This report—by concerned residents of Reading, MA—responds to the McDonald’s-commissioned study concluding that the proposed new double drive-through restaurant at 413 Main Street would have a “negligible” traffic impact. This report finds traffic could double based on the site plan configuration combined with McDonald’s restaurant automation technologies, mobile app usage, marketing efforts, and other factors not mentioned in the McDonald’s study.

McDonald’s: Severe Traffic Impacts from a Double Drive-Through plus Mobile Marketing and AI/Automation Technologies

To: Andrew MacNichol, Community Development Director
From: Ryan A. Percival, P.E., Town Engineer;
CC: Community Planning and Development Commission;
Date: August 31, 2023
Re: Proposed Site Re-development 413 Main Street - McDonald's

**Re: Response to Comments Letter
McDonald's Restaurant
413 Main Street
Reading, MA**

Figure 1: Existing Traffic at Nearby Intersections are Already at the Worst Level of Traffic Service

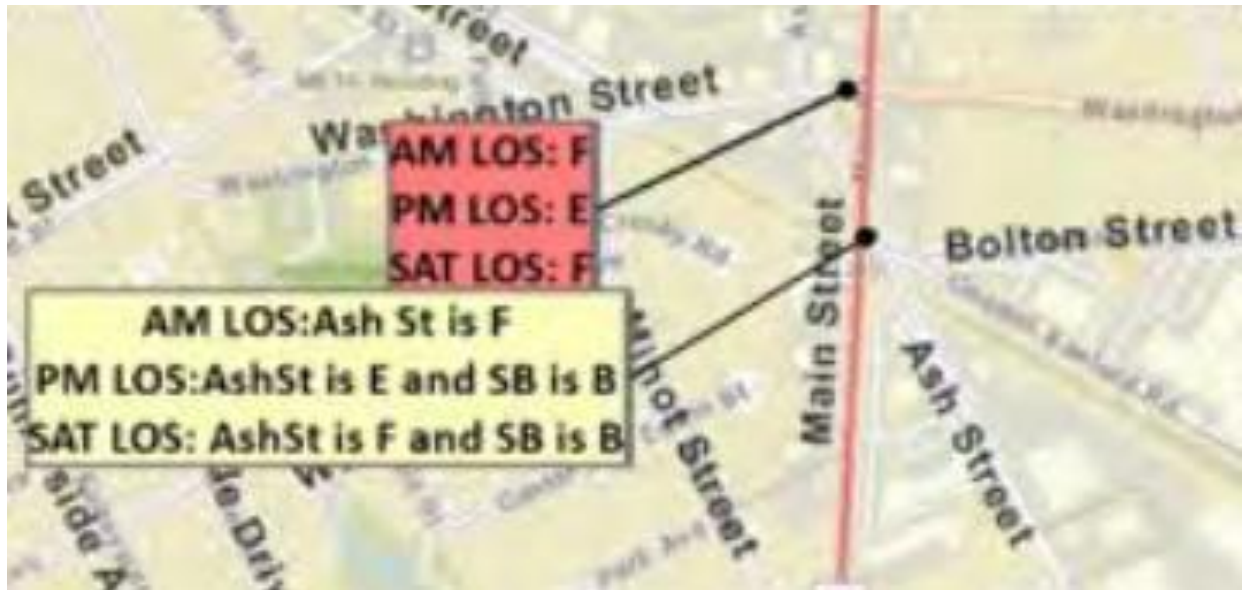
A recent Town-commissioned study performed by Green International Associates, and released in 2021, documented that the intersections at Washington and Main, and at Ash and Main – just north and south of McDonald’s—are already at an “E” or “F”³ as shown in the figure below.

Traffic engineers classify traffic conditions on an “A” through “F” scale for the “level of service” (LOS). A site with an LOS of “F” means that every vehicle moves in lockstep with the vehicle in front of it. Roads that face near-constant traffic jams are at a level of service of F.

The Plan is Engineered to Handle Double the Vehicle Traffic

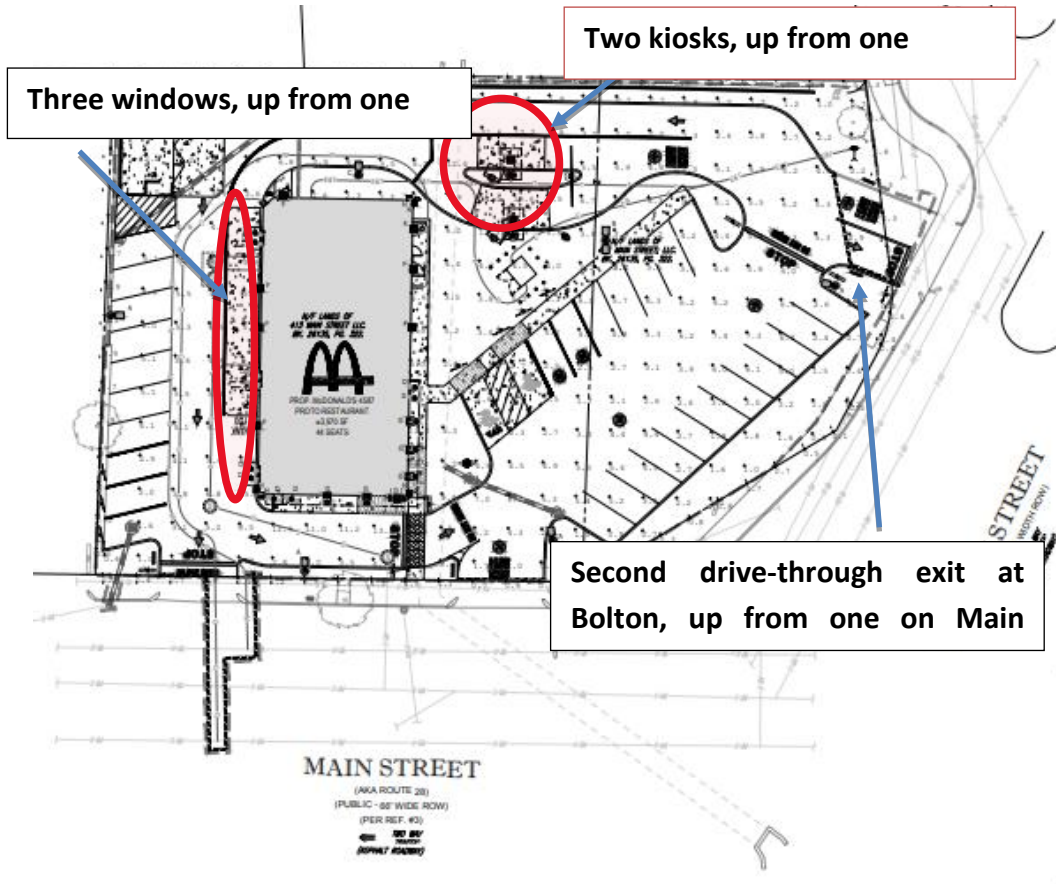
The new McDonald's site plan is engineered to process at least twice as many vehicles.

- The existing McDonald's has one ordering kiosk. The new one would have two ordering kiosks—**twice as many**.

PLAN DESCRIPTION
**EXISTING
DRIVE-THRU
STACKING EXHIBIT**

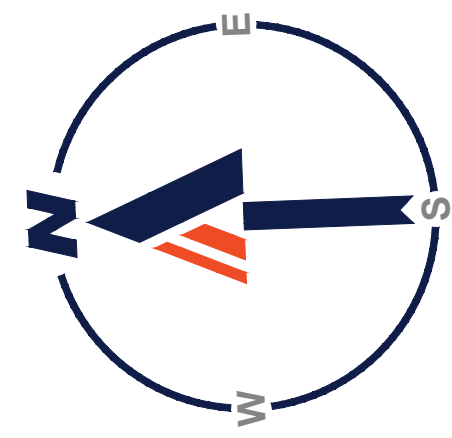
Comment 3: ***Drive-thru stacking capacity:** Please provide the total lane stacking capability in feet of both the existing drive-thru and the new proposed dual order point. Our bylaw requires 198ft in length, of which at least 90ft are for ordering and transacting, and at least 54ft stacking capacity exiting onto the road.*

Response 3: The total lane stacking capacity for the existing drive-thru is 105 FT (approx. 6 vehicles) from the present window to the order point, and 137 FT (approx. 8 vehicles) from the order point to drive-thru lane entrance at the Main Street ROW. The distance between the existing present window and the exit drive is 55.2 FT.
